**Eight Discipline Report (8D Report)**

То:	8D report No.: CPTP0326		
From: : Chicony Power Technology	RMA claim No.: N/A		
CC: N/A	Chicony P/N: A045R07DH		
	Customer P/N:		
Submit date: <b>2014/3/3</b>	Product description: 45W adapter		
Receive date: 2014/3/26	Defect D/C or Lot No.:

Subject: There are 0.1% productions which has voltage drop phenomenon during burn in process.

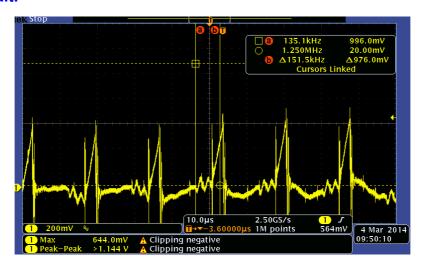
2. We measured the V<sub>sense</sub> waveform of defective sample, and find the voltage waveform has oscillating phenomenon. We infer it should be the transformer T1 interfere the control circuit.

- 4. We modified the control loop parameters of 5pcs defective samples as follow:
  - (1) R52 change from 3.6kohm to 560ohm,
  - (2) R53 change from 20kohm to 5.6kohm,
  - (3) R54 change from 15kohm to 51kohm
  - (4) Remove C56(was 1nF).

Modified R52/R53/R54/C56 can improve voltage drop issue.
